**Re: Response to EPA Comments on the Draft RI Report
J-7026-02**

This letter summarizes our responses to the comments provided to the Washington State Department of Ecology (Ecology) by the United States Environmental Protection Agency (EPA) on August 3, 2000, regarding the Remedial Investigation report (RI) for the J. H. Baxter Arlington (Baxter) site. The EPA comments were reviewed and discussed by Hart Crowser and Ecology on August 16 and 25, 2000. The responses given below are based on these discussions and are a joint effort on the part of Hart Crowser and Ecology. We understand you intend to forward these responses to the EPA.

ATTACHMENT D
GROUNDWATER FLOW ALONG CROSS-SECTION A-A'

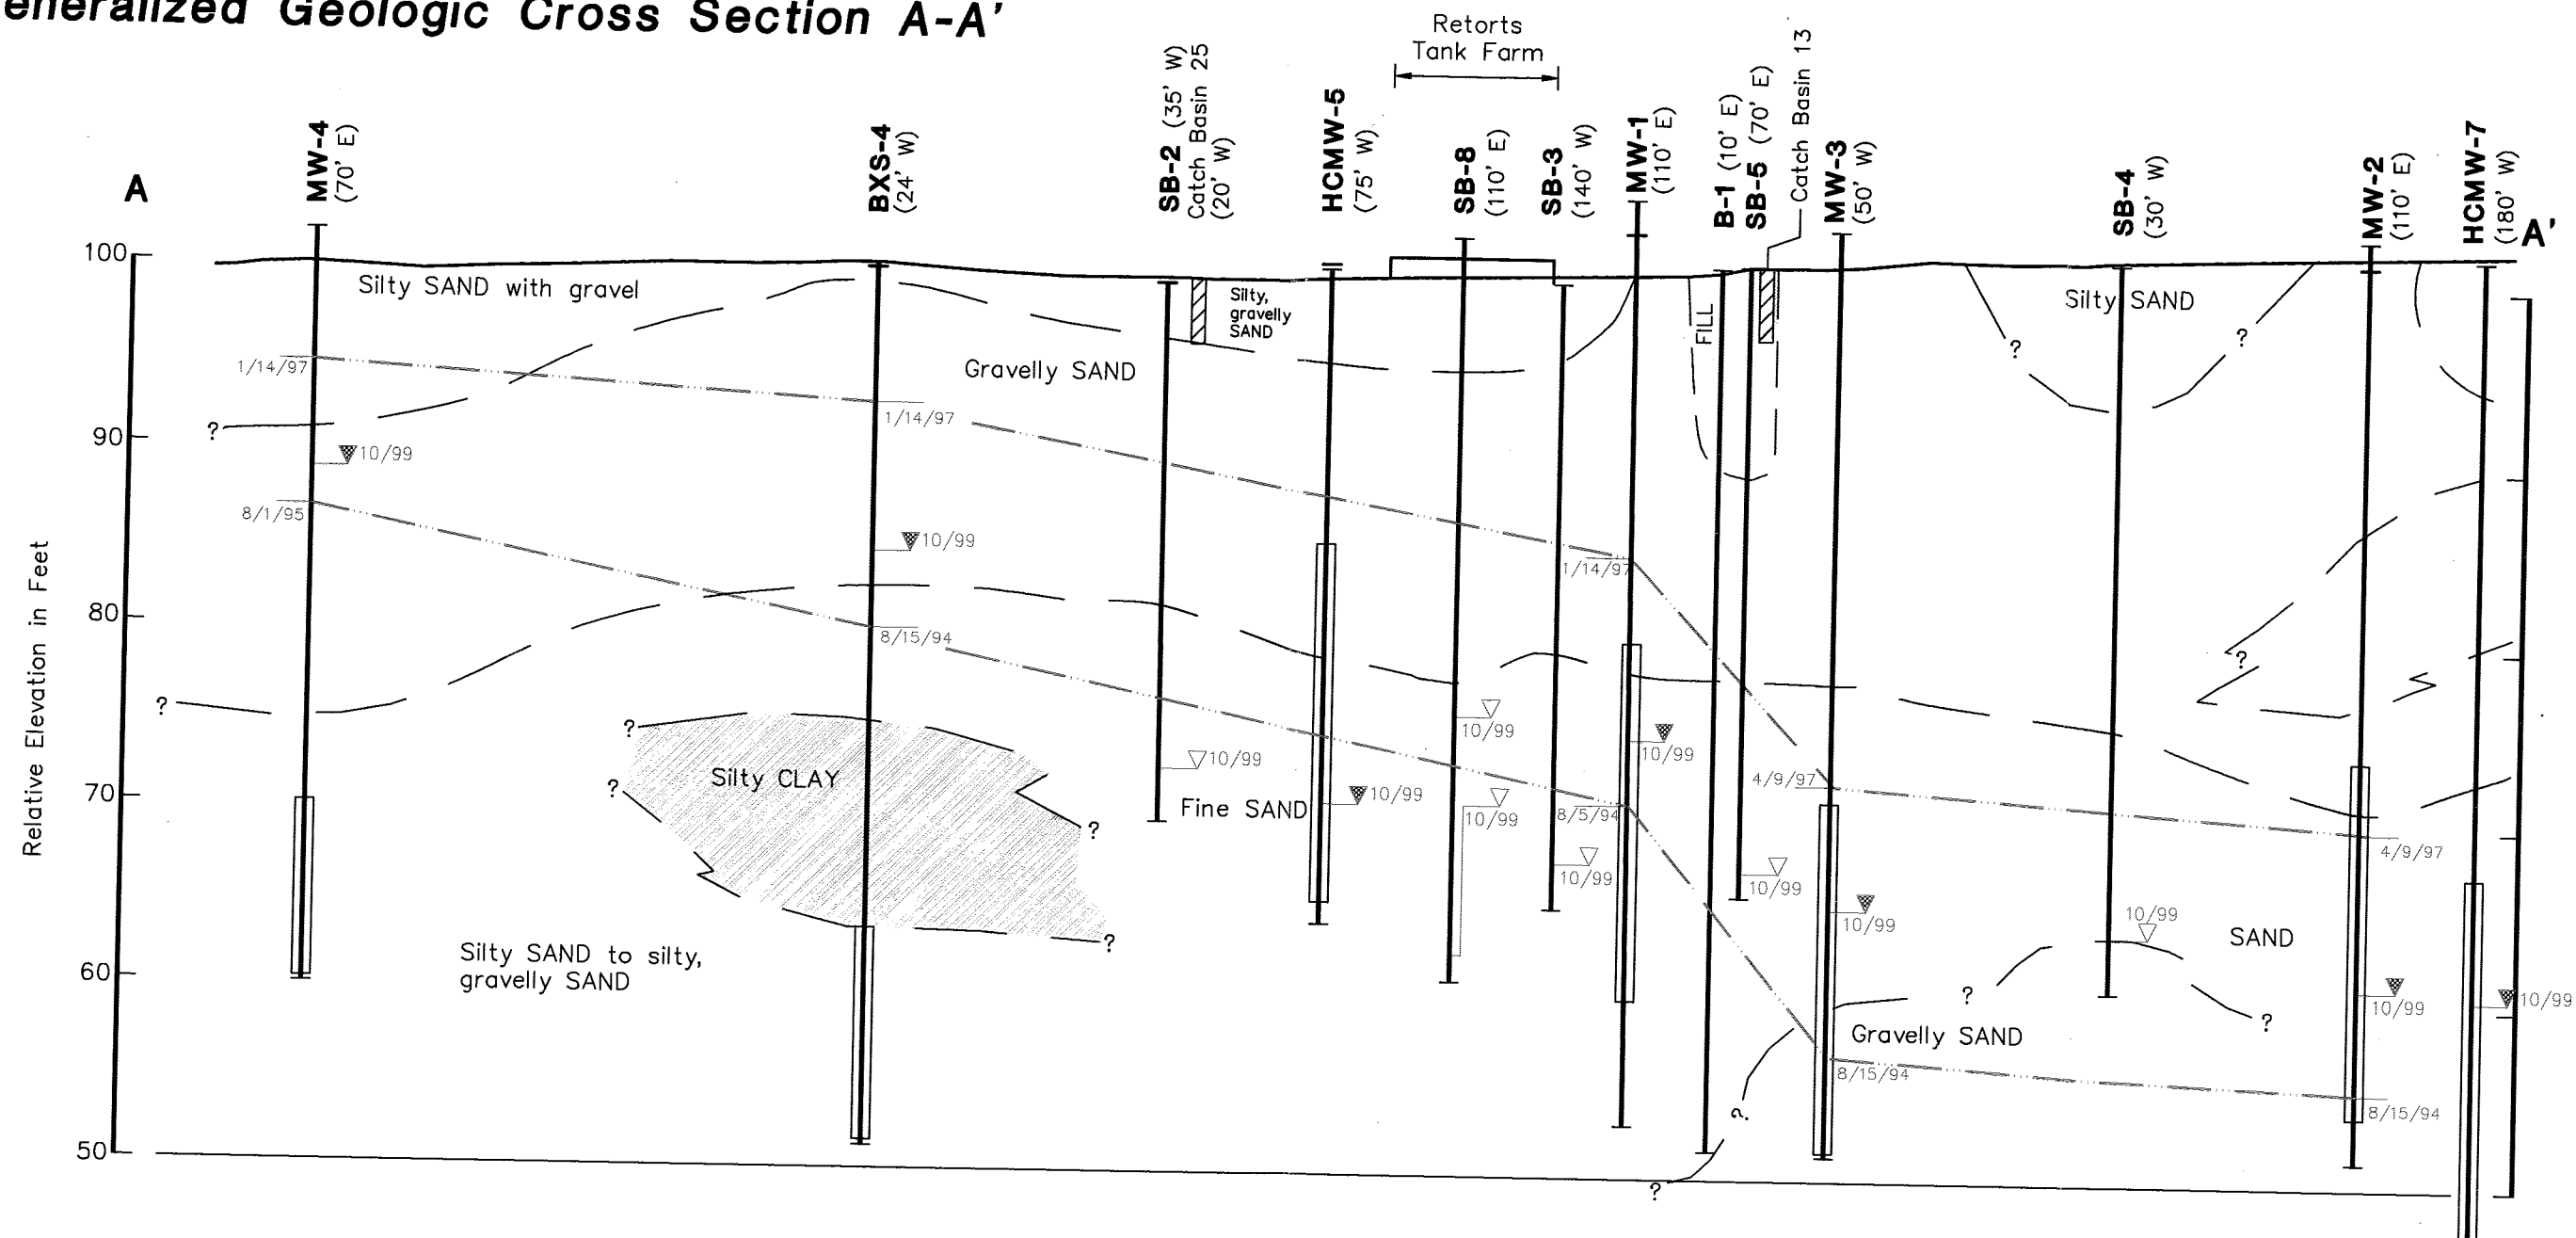
The groundwater gradient at the site and in the general area has been well characterized as flowing to the northwest, as explained above in the response to comment 4. Data from Parcel B monitoring wells indicate that groundwater from Parcel B flows also to the

northwest (see Cross Section A-A', Figure 6 of the RI - Attachment D). PCP has not been detected in wells to the south, southeast, or southwest of the observed area of groundwater contamination. There is no evidence of southward migration of groundwater or groundwater contaminants from either Parcel A or the Woodwaste Landfill.

Regional Geology and Well Location Map

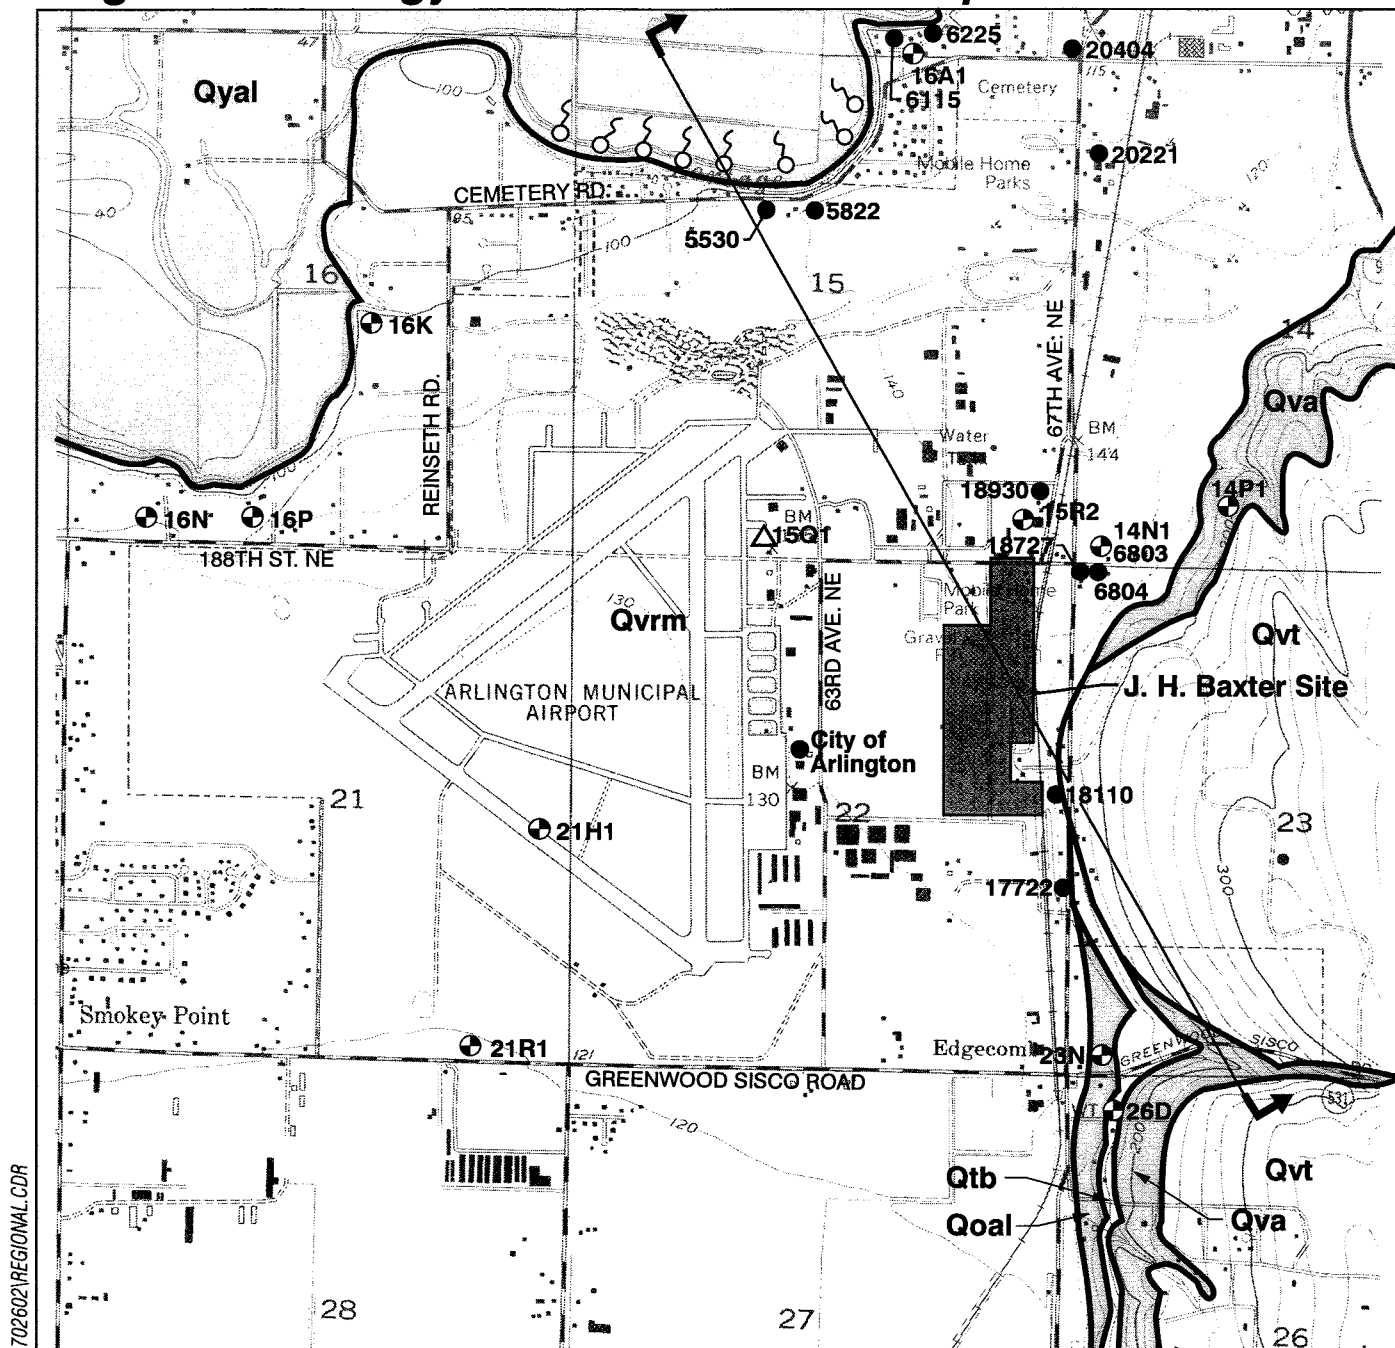
- ✓ 30. There should be a more detailed map similar to Figure 3 which includes all the supply wells in the area, and which documents in detail how the wells were or were not found. If Portage Creek is considered a discharge boundary for the plume it needs to be documented with actual ground water data. If the plume is likely to go beyond the Creek, then nearby wells found on the north side of it should also be included in the mapping and sampling. Similarly, if Quilceda Creek is determined to be a discharge boundary for the south side of the site similar concerns have to be investigated there.

All water supply wells, to the best of our knowledge, are included on Figure 3 of the RI. Table 1 has a list of well locations, information, and how and when each well was inventoried. These are included in Attachment I.

Regional hydrogeologic data summarized on Figures 3 and 4 of the RI and a Snohomish County groundwater study (Attachment B) support the likelihood of discharge to Portage Creek. Portage Creek acts as a hydrogeologic boundary to groundwater flow so impacts to wells on the other side of the Creek would not be an issue. The Snohomish County Quilceda/Allen Basin Watershed Study indicates that surface water near the site may flow into Quilceda Creek; however, regional and site groundwater data clearly indicate flow from the site to the northwest toward Portage Creek.

Monthly Precipitation and Groundwater Elevations in Arlington, WA

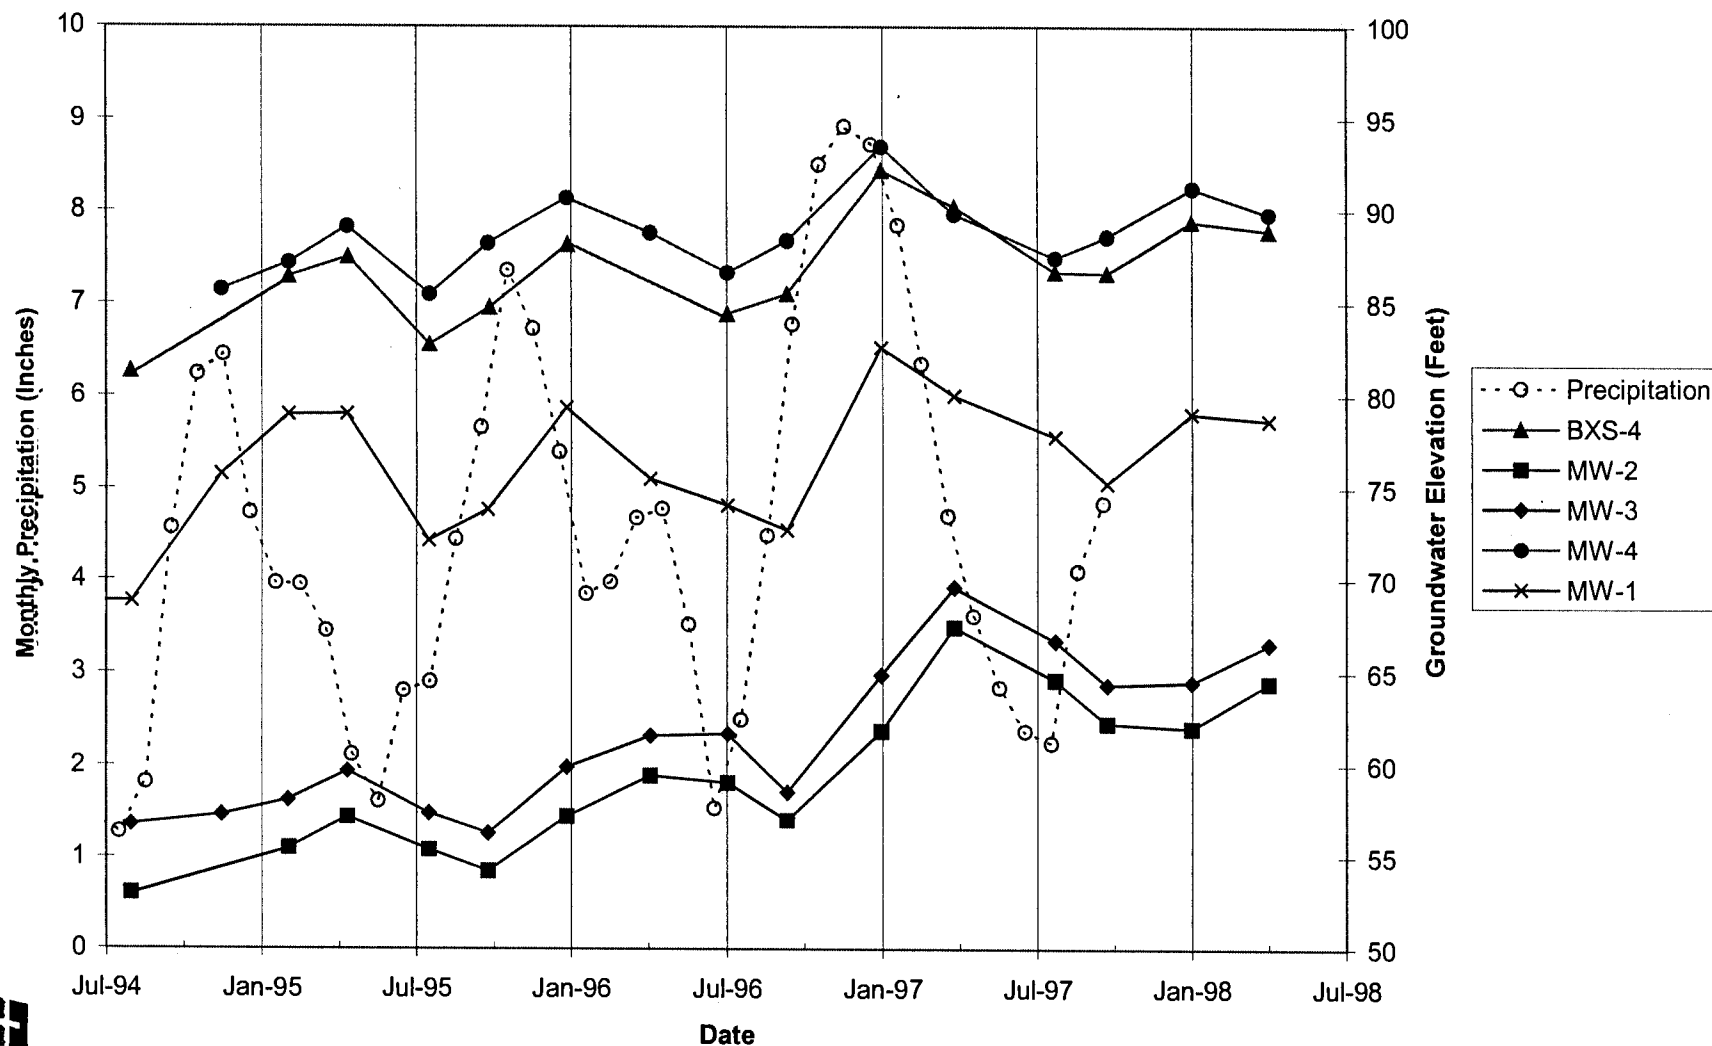
33. Figure 6, 7 and 8. The water elevation in the wells has varied by many feet over the years presented (about 15 feet between 1994 and 1997 in some wells). This variability makes any comparison of water quality and gradients very difficult. To verify the actual gradients it may be necessary to install transducers or go to a more routine (weekly) water level monitoring schedule. Water quality may have to be compared to periods where the well has had similar water elevations rather than just to the previous water samples in order to provide reasonable comparisons of the data to show trends. It is not clear why BT-S and BT-W were not completed as monitoring wells since these borings appear to be located near the source areas. Wells in the source areas should be installed soon to attempt to characterize the sources and begin to have a data set of those areas.

Ten years of quarterly groundwater monitoring has provided a consistent measure of groundwater elevation and gradients. Seasonal variations are well characterized, and consistent year to year and in general relation to variations in precipitation seen during this period of time. Table 2 of the RI provides the available groundwater elevation data and Figure 6 of the Work Plan show seasonal variation of water levels relative to precipitation. These are included in Attachment J.
